## DOCUMENT CHANGE REQUEST

DCR number 264 Changes required for: General

Title: Transistors Low Power NPN, based on type 2N3700

Number: 5201/004

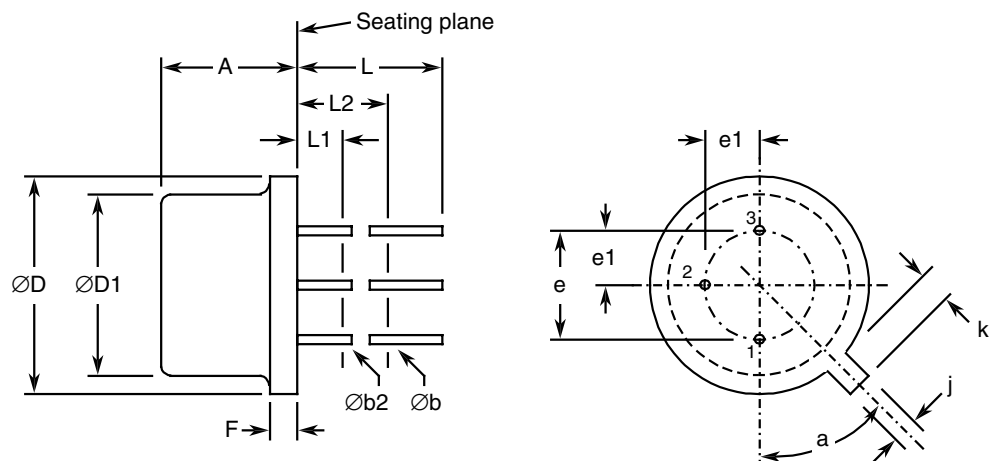
1. Rewording and restructure of various sections and paragraphs of the specification plus other editorial changes based on the layout and editorial content of other Detail Specifications already converted to ESCC format.
2. Deletion of any redundant paragraphs and information, e.g. Test circuits and mechanical paragraph.
3. Para 1.7 - High Temperature Test Precautions requirements moved to be a note to the Maximum Ratings table.
4. Deletion of obsolete lead finish D7 / Variant 03 from the available range (not supported by STM).
5. Figure 1 Parameter Derating Requirements - moved to be a note to the Maximum Ratings table.
6. Figure 2(a) - Dimensions .e. (formerly fa) and .a. changed from "T.P." to "BSC". The drawing harmonized with TO-18 outlines for similar STM components.
7. Figure 3 - Note for the CCP stating that the lid is not connected to any terminal added.

- For  $T_{amb}$  or  $T_{case} > +25^{\circ}C$ , derate linearly to 0W at  $+200^{\circ}C$ .
- When mounted on a 15 x 15 x 0.6mm ceramic substrate.
- For Variants with tin-lead plating or hot solder dip lead finish all testing performed at  $T_{amb} > +125^{\circ}C$  shall be carried out in a 100% inert atmosphere.
- Duration 10 seconds maximum at a distance of not less than 1.5mm from the device body and the same lead shall not be resoldered until 3 minutes have elapsed.
- Duration 5 seconds maximum and the same terminal shall not be resoldered until 3 minutes have elapsed.
